SUBJECT: Forwards response to 830808 summary of site audit for
 environ qualification of equipment & to Section 3.4 of NRC
 831011 review of environ qualification of equipment.

December 1, 1983
ANPP-28332 - WFQ/RJP

Subject: Palo Verde Nuclear Generating Station
(PVNGS) Units 1, 2 and 3
Docket Nos. STN-50-528/529/530
File: 83-056-026; G.1.01.10

- References:
1. Summary of Site Audit for Environmental Qualification of Equipment, E. A. Licitra, NRC, dated August 8, 1983.
 2. Letter from G. W. Knighton, NRC, to E. E. Van Brunt, Jr., APS, dated October 11, 1983. Subject: Staff Review of Environmental Qualification of Equipment for Palo Verde.

BECHTEL LOS ANGELES		CONTAINMENT BLDG CONDUIT & TR. PLAN AT EL 100 FT LEVEL A ZCAA, ZCAB	
ARIZONA NUCLEAR POWER PROJECT PALO VERDE NUCLEAR GENERATING STATION		DATE 1/8/70 DRAWN BY 16497	CHECKED BY 13-E-ZCC-CSJ

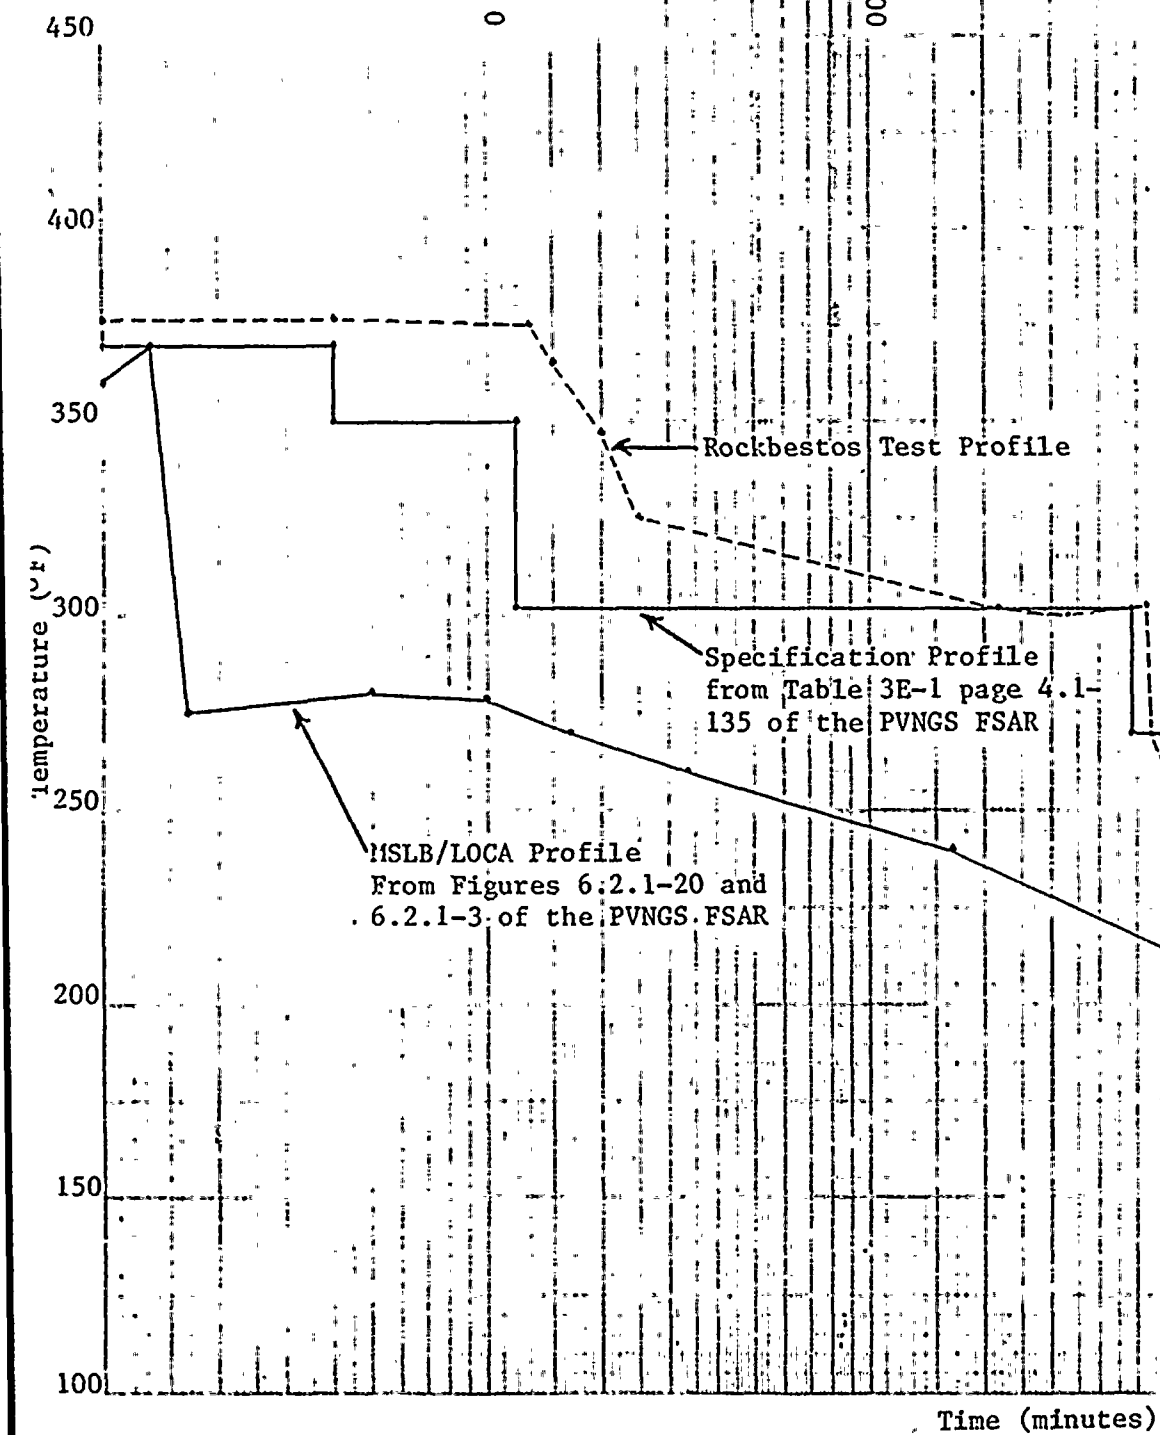
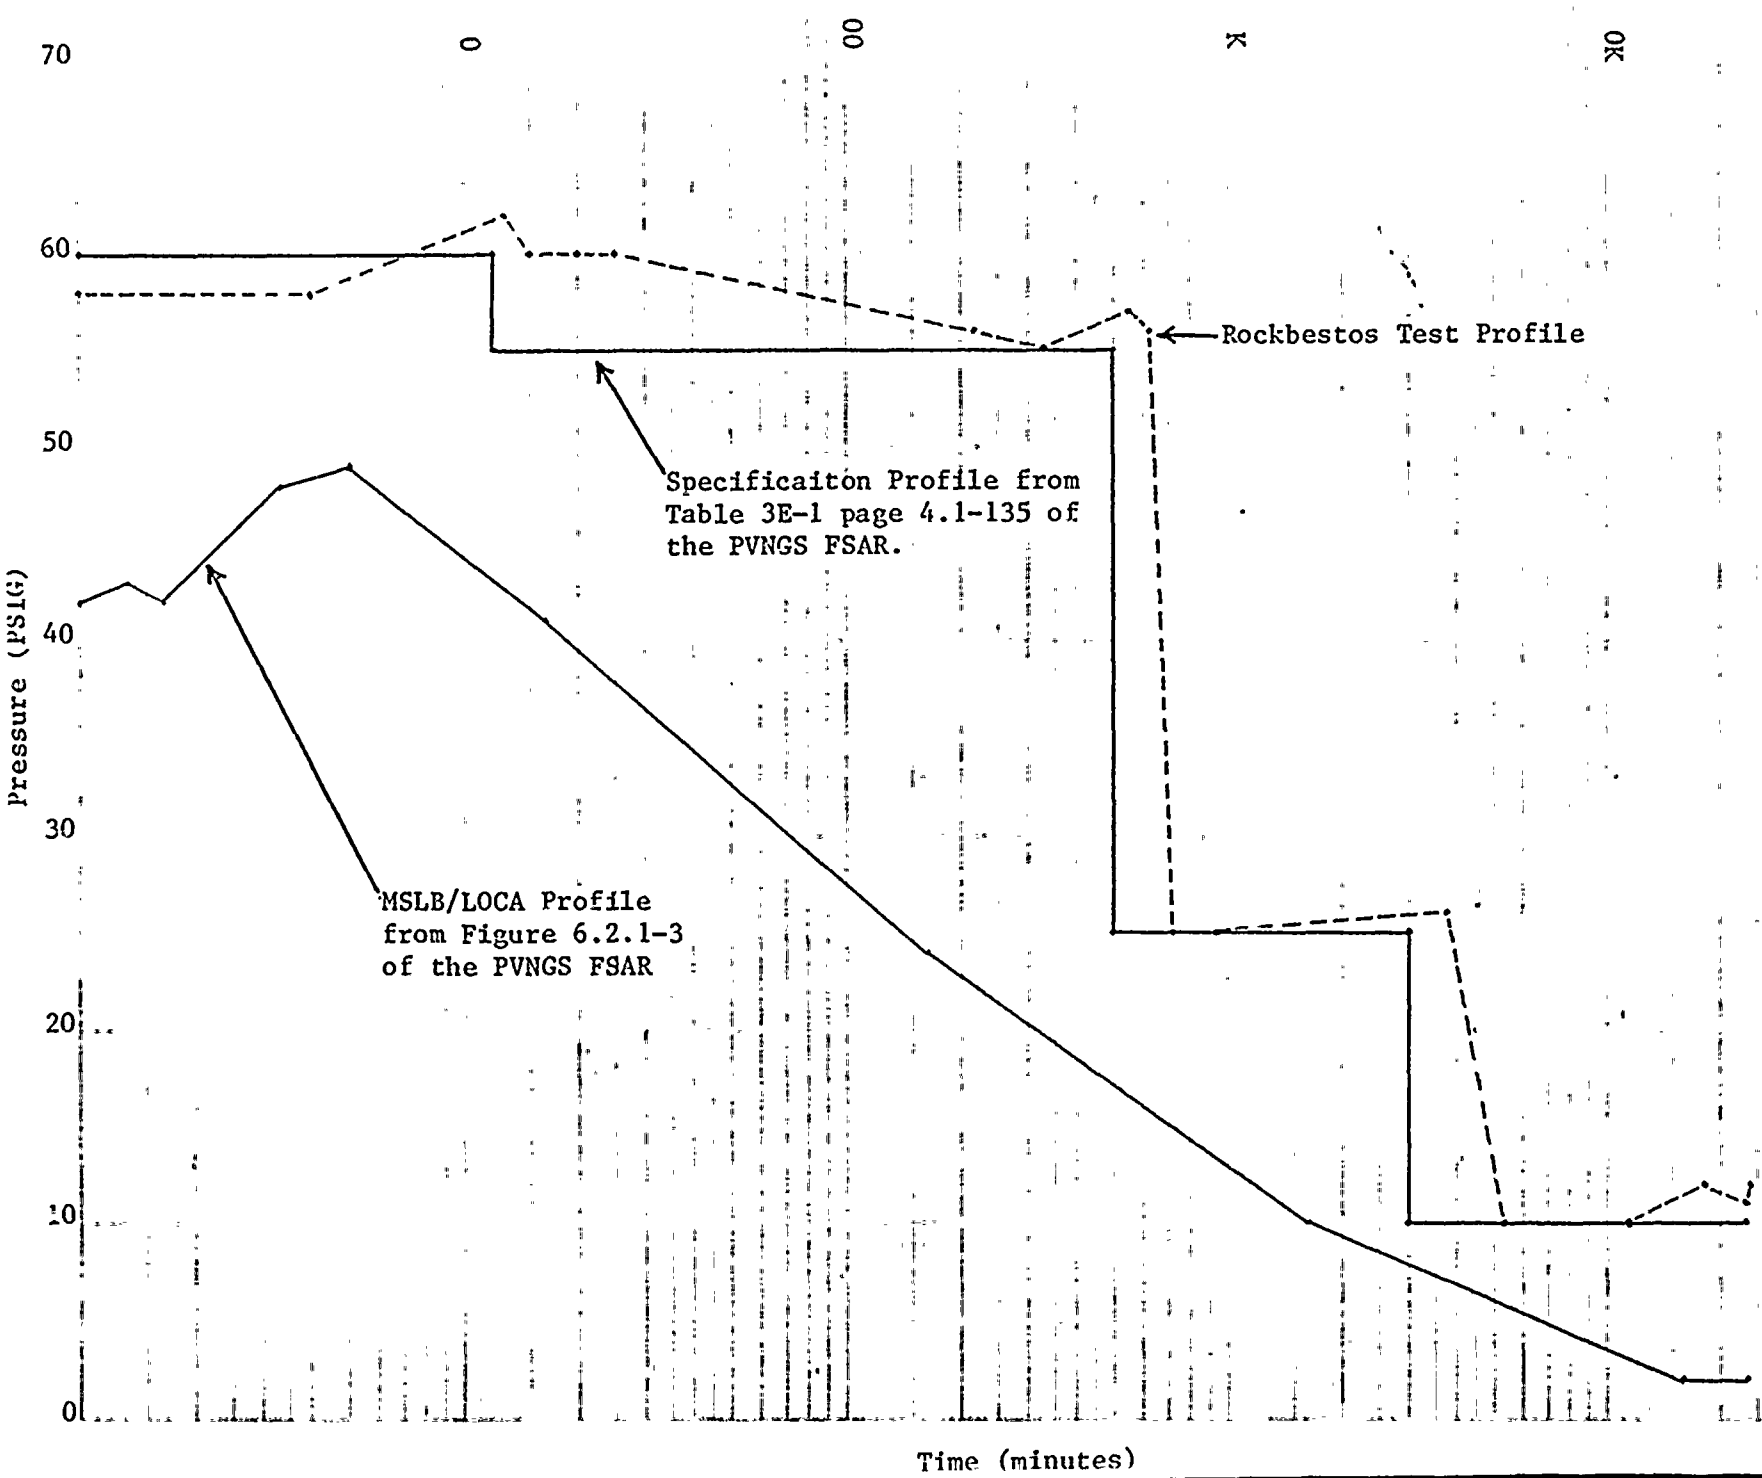
- (4) During the plant walkdown, two items (Rockbestos cable inside containment and the pre-amplifier for the ex-core detectors) could not be located and one item (ASCO solenoid valve) didn't have a name plate attached. The applicant should address and correct this situation.

The excore safety channel detector preamps, Channels C and D, are located at the 91' elevation of the Containment Building as shown on the plant Electrical-Physical Drawing 13-E-ZCC-007 Rev. 20 (Attachment 1). The post-accident (RG 1.97) excore preamps, Channels A and B, are located in the unit Auxiliary Building to ensure long term post DBE operability by removal of the sensitive electronics from the harsh environment of containment. The locations were verified in a walkdown performed by an APS qualification engineer. Qualification of the post-accident units is currently underway.

Figure 1 Rockbestos Arrhenius Aging Curves

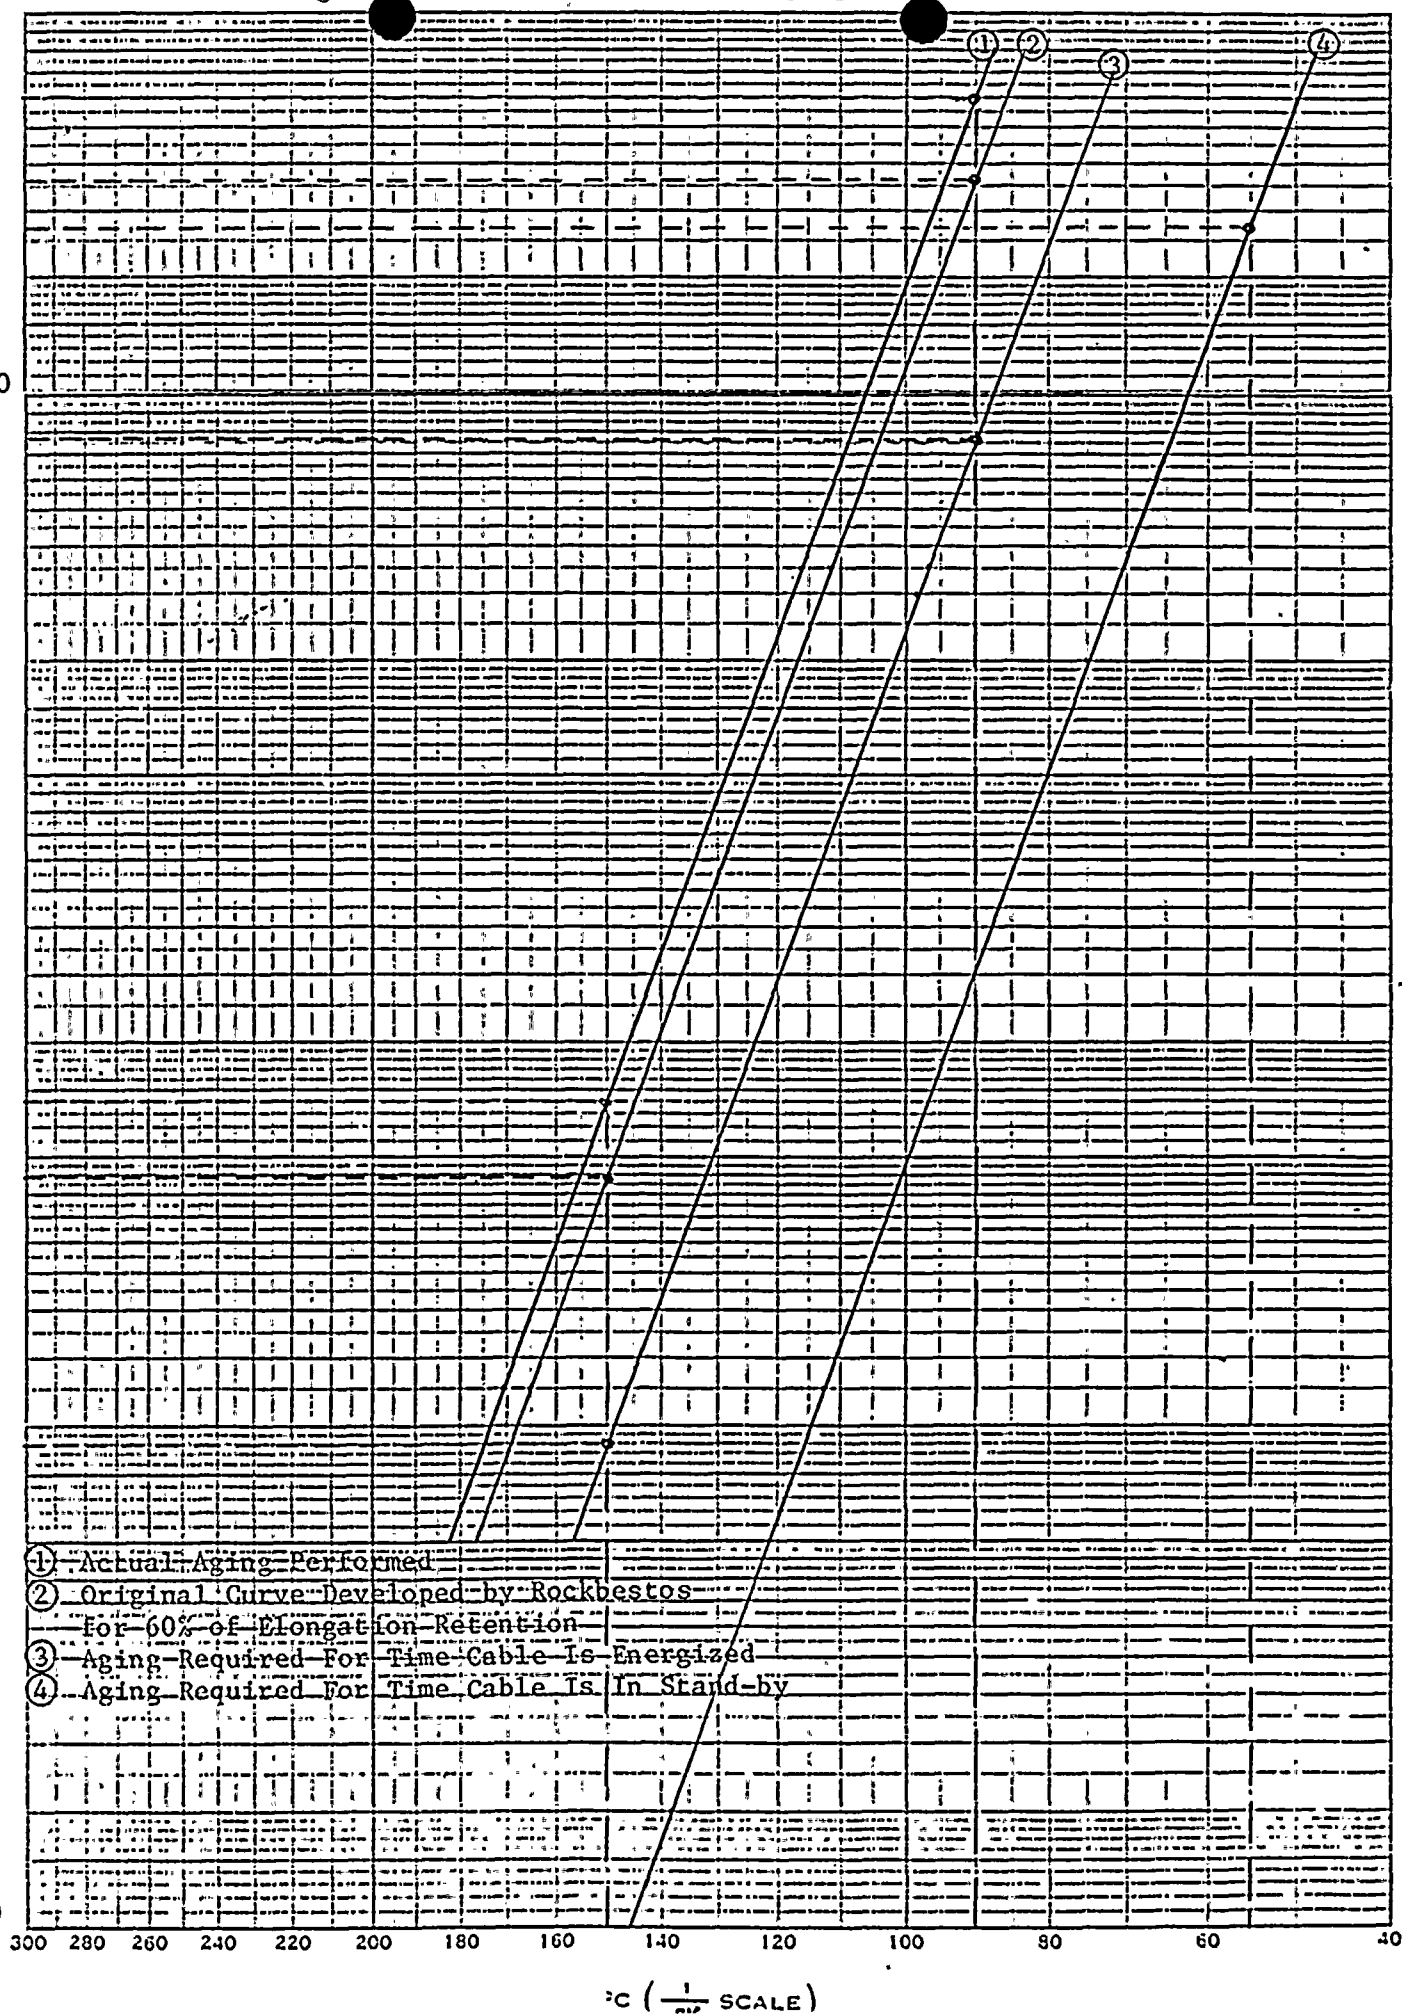
- (d) Required operability time for the cable is 30 days, but the test duration was only 16 days. An explanation should be provided on how 30 days operability, with margin, was achieved.

- (d) See the analysis in Attachment 3. This analysis extrapolates the excess temperature used in the LOCA/MSLB test to extend the time operability of the LOCA/MSLB test. The calculation is based upon Arrhenius methods to relate the time/temperature effects on the subject cable. The results indicate a post-accident operability of 116.8 days which is more than adequate to meet the 30 day operability period.

Referring to original Arrhenius Plot. Figure 1 Line 2

BY: <i>E. J. Gouvier</i>	DATE: 24 Aug 83	SUBJECT: ASCO SOLENOID VALVE T° RISE (IN-SITU)	SHEET NO. 2 (RΦ) of 5
CHECKED BY: <i>J. J. Krawiec, Jr.</i>	DATE: 8/24/83	TEST	JOINT FILE: 13-EC-SI-A01

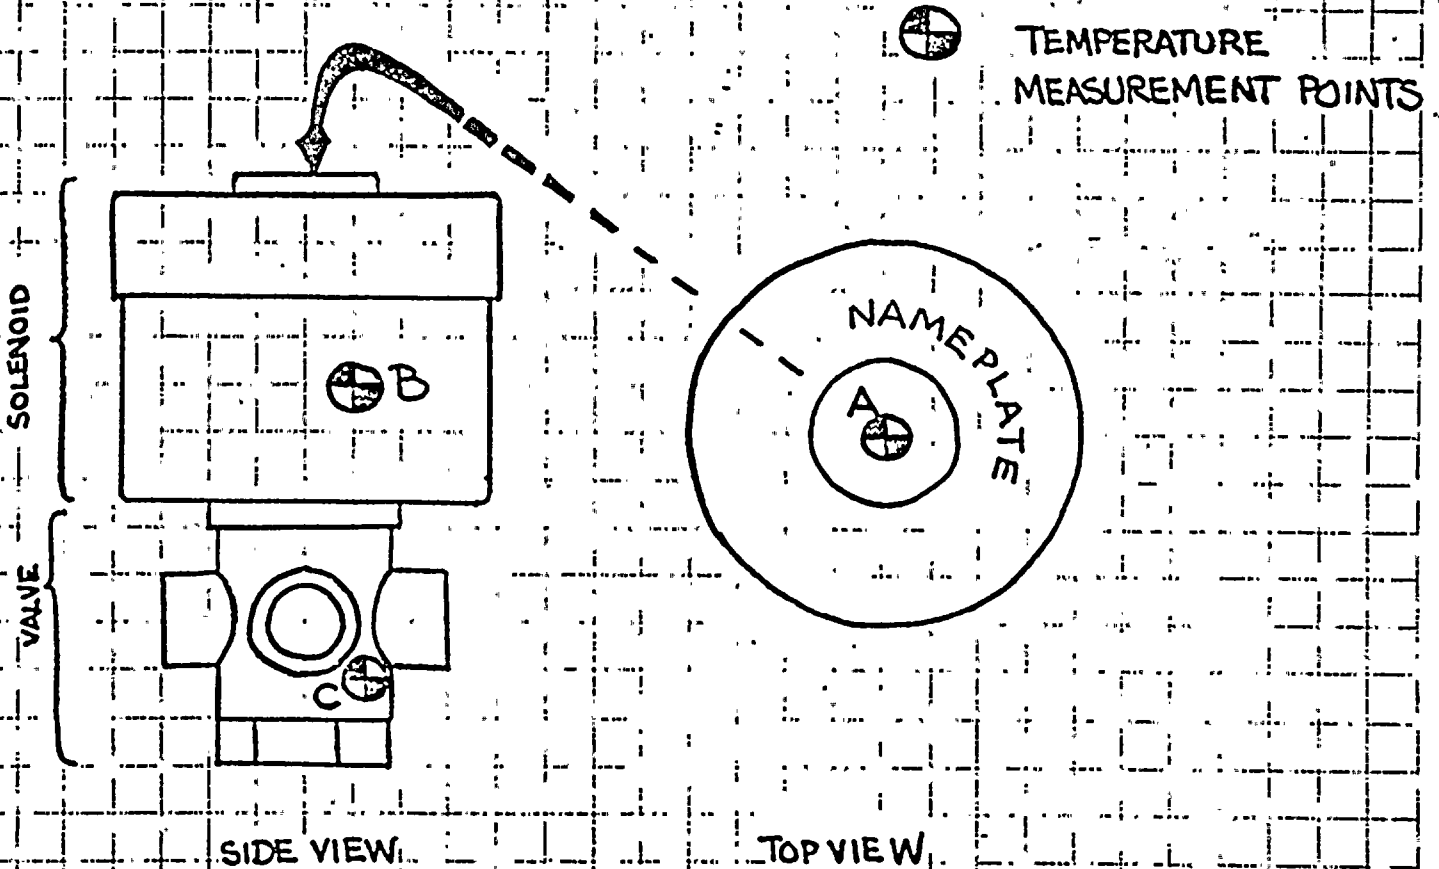
- (a) The aging analyses didn't take into account the temperature rise for the valve caused by the energized condition. During the plant walkdown, a thermometer placed on the surface of an energized valve indicated a temperature of about 140°F while the ambient temperature was only 98°F. Temperatures inside the valve (coil and seat) were probably higher. Therefore, the applicant should include an aging analysis that takes into account the temperature rise caused by the energized condition.

- (a) An In-Situ Test was performed on these solenoid valves, as documented in APS Test Report 13-EC-SI-A01, Rev. 01 to establish the temperature rise associated with continuous coil energization.

This data has been factored into an analysis that was performed to determine the effect of coil temperature rise on the qualified life of ASCO solenoid valves. The analysis is based on the operation of associated pneumatic valves, i.e., normally open or normally closed. It was concluded that the temperature rise affects only the pneumatic valves that are normally open since the ASCO solenoid valve is required to be energized to maintain the pneumatic valve in the open position.
